Proposed Elevation 1  
1:100 @ A1

**PLANNING**

Client:	Truelove Property			
Project:	Castle Exchange			
Phase/Location:	Castle Exchange, Broad Street, Nottingham, NG1 3AP			
Drawing:	Proposed Elevation 1			
Scale @ A1:	Scale @ A3:	Date:	Drawn:	Checked:
1:100	06/14/21	ZM	OC	5413
Drawing Ref.:	5413-HMA-CE-ZZ-DR-A-00212			Revision
				P3

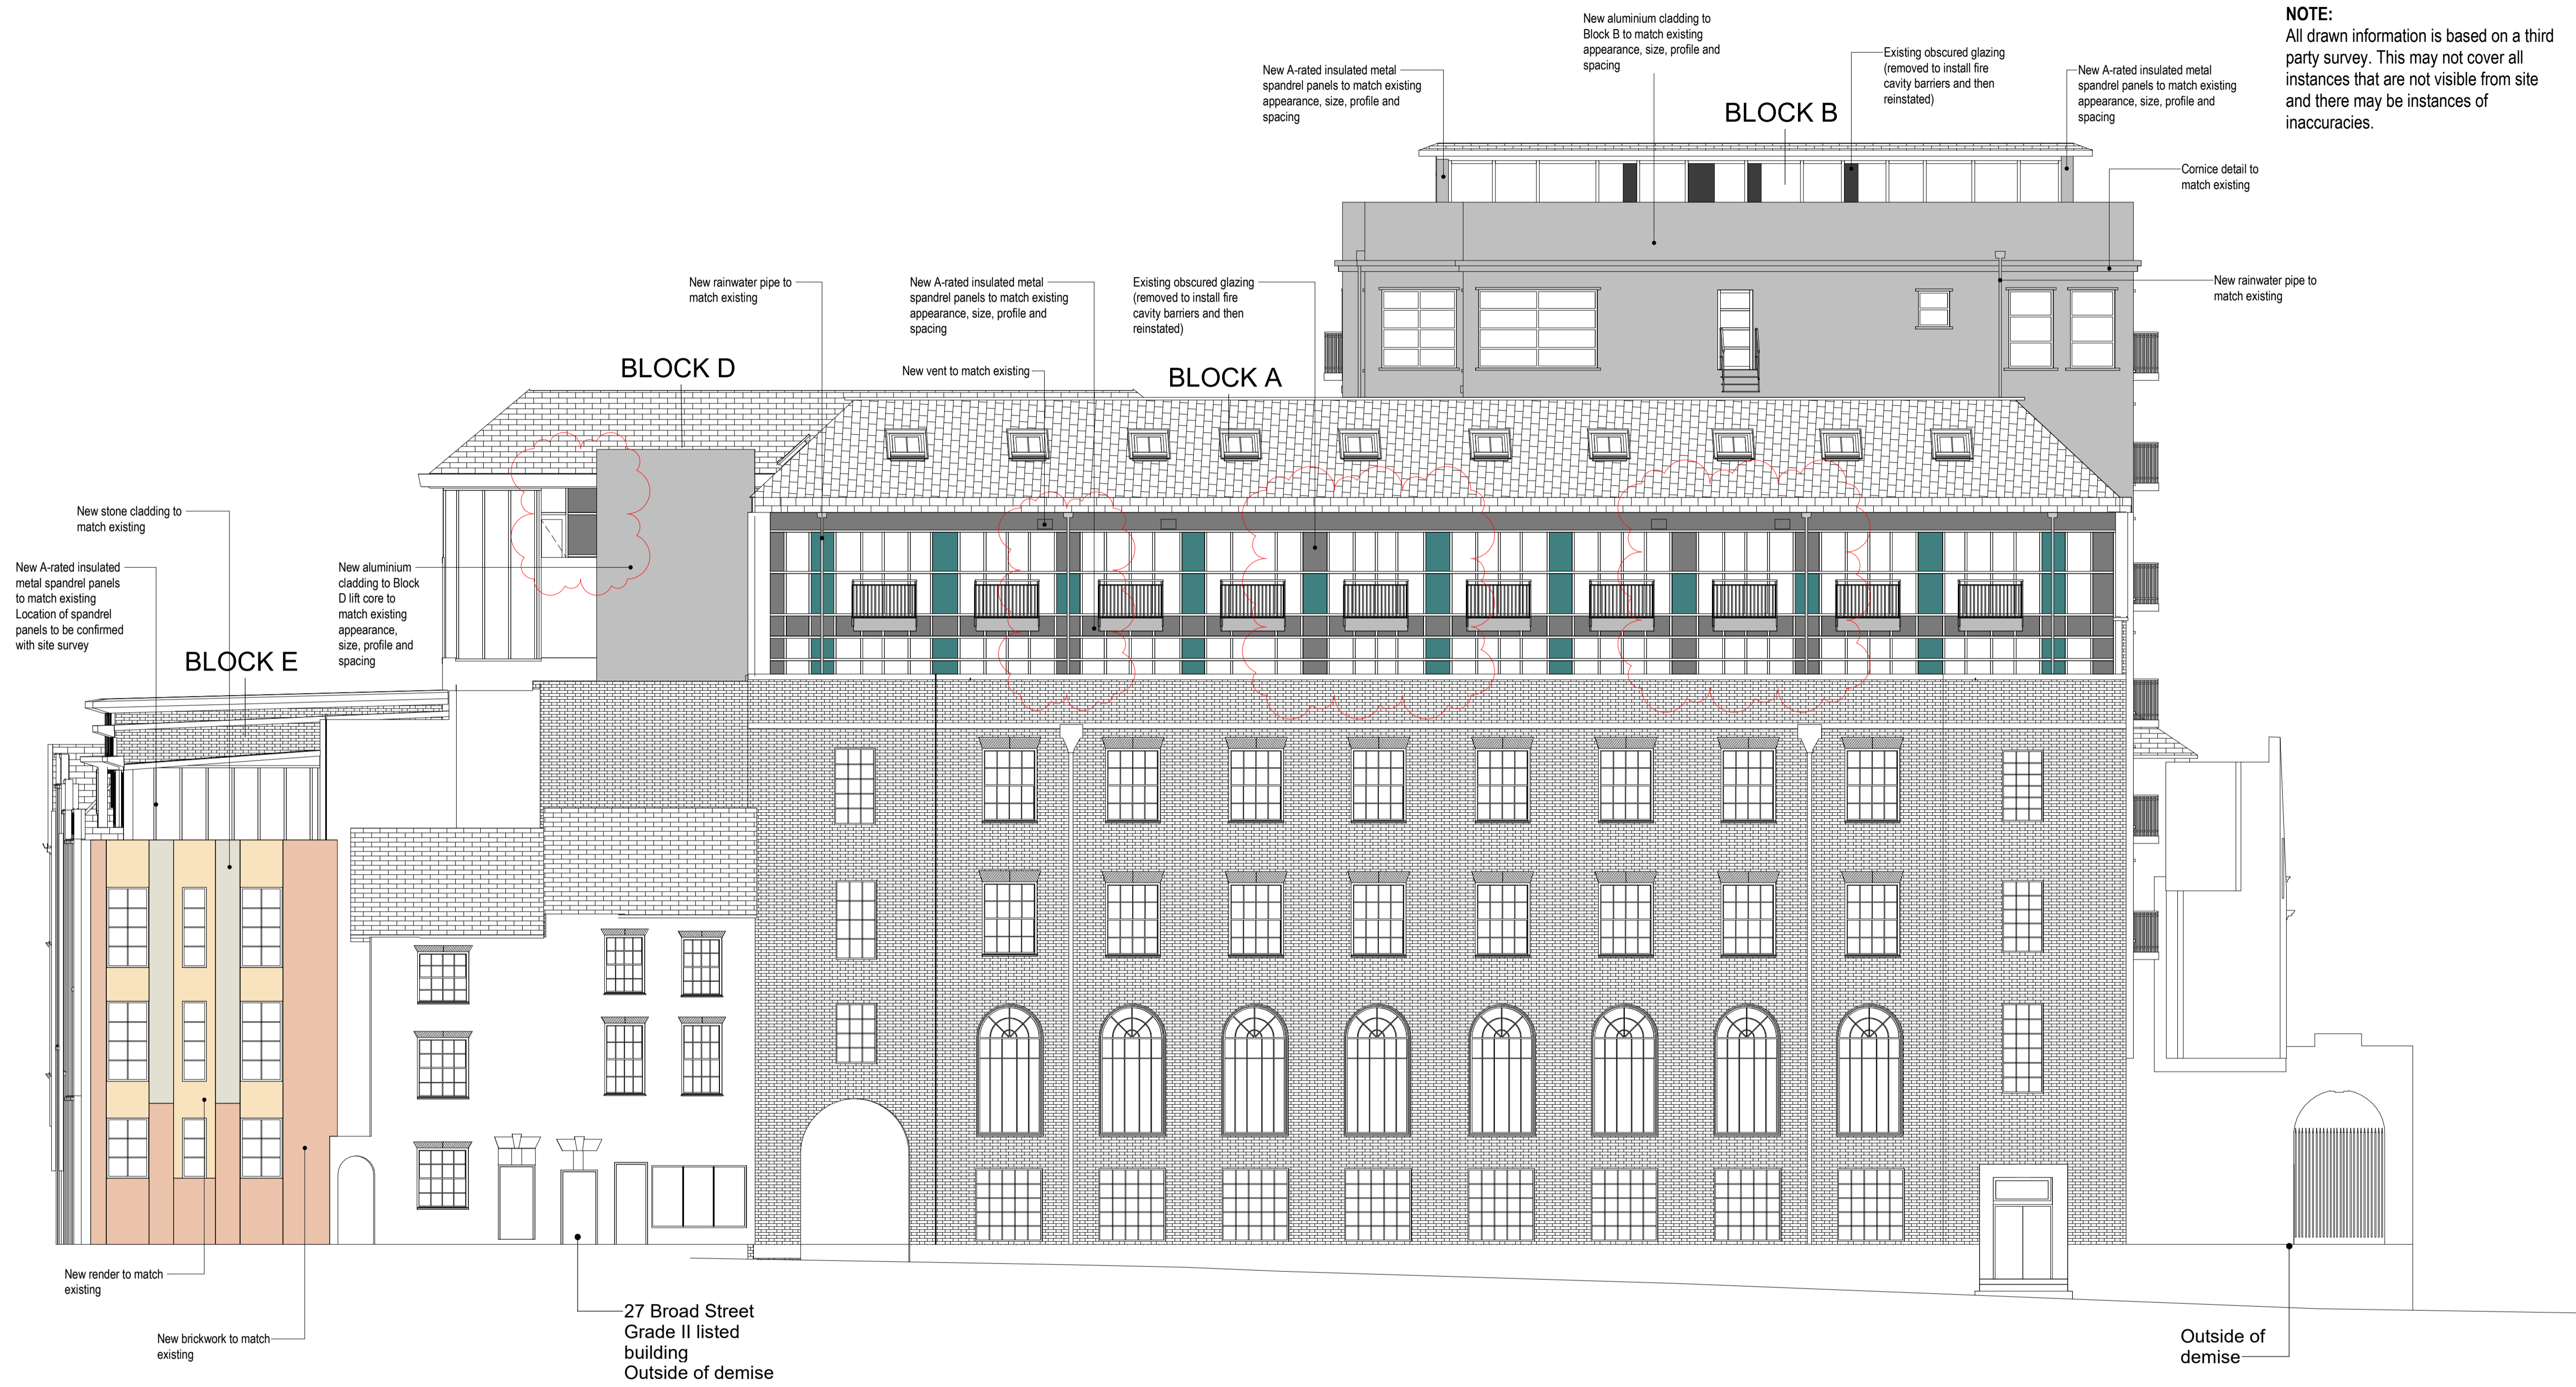
Revision	Description	Date	Drawn	Checked
P03	Spandrel panels changed from glass to metal where required	29-01-2024	MT	OC
P02	Updated with survey information.	12-10-2021	ZM	OC
P01	Issued for planning.	01-07-2021	ZM	OC
